# Access Compliance Report

## Public Rights-of-Way

Intersection ID: 52303	Main Street: VIBURNUM_CT	Cross Street: SNOWBELL_CT	Location: NE
ADA ID: 87A39C806940	Ramp Type: PerpDiag	Initial Pass/Fail: Pass	Overall Compliance: No
			Severity Score: 15.25

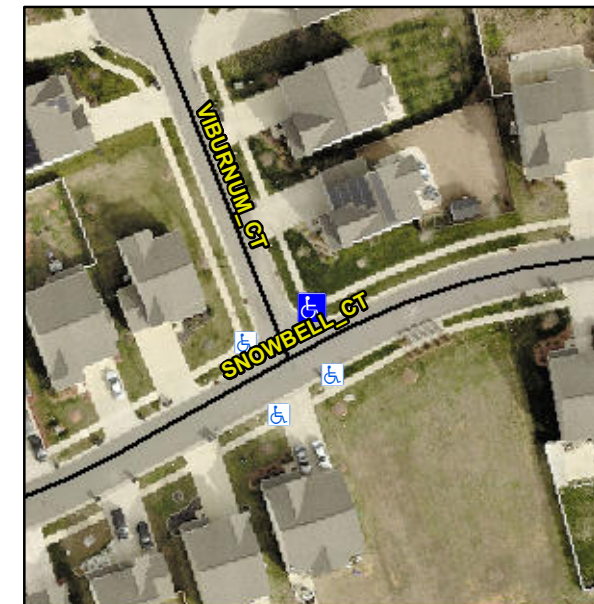
**Not Found, R304.5.3, R304.2.1, R305.2, R302.7, R302.7.2**

Compliance	Description	Data	Compliance	Description	Data
N/A	Ramp Length (in)	73.0	Yes	Ramp Slope (%)	5.6
Yes	Ramp Width (in)	48.0	No	Ramp XSlope (%)	3.8
N/A	Flare Type LT	Sloped	N/A	Flare Type RT	N/A
N/A	Flare Slope LT (%)	4.2	N/A	Flare Slope RT (%)	8.8
N/A	Flare Traversable LT?	No	N/A	Flare Traversable RT?	No
Yes	Landing Length (in)	49.0	Yes	DWS Provided?	Yes
No	Landing Width (in)	42.0	Yes	DWS Contrast?	Yes
Yes	Landing Slope (%)	1.6	Yes	DWS Length (in)	24.0
No	Landing X Slope (%)	3.6	Yes	DWS Full Width?	Yes
N/A	Landing Curb? (Y/N)	No	No	DWS Offset (in)	5.0
N/A	Shared Landing?	No			
No	Gutter Ponding?	Yes	Yes	Gutter Slope (%)	4.5
No	Gutter Lip Ht (in)	1.5	No	Gutter X Slope (%)	3.1
N/A	Painted X Walk1?	No	N/A	Painted X Walk2?	No
	X Walk 1 Direction	To W		X Walk 2 Direction	To S
N/A	X Walk 1 Width (in)	N/A	N/A	X Walk 2 Width (in)	N/A
	X Walk 1 Slope (%)	1.0		X Walk 2 Slope (%)	1.3
	X Walk 1 X Slope (%)	1.8		X Walk 2 X Slope (%)	0.9

**Remove & Replace Curb Ramp With Two New Directional Ramps or Equivalent. Remove & Replace Gutter.**
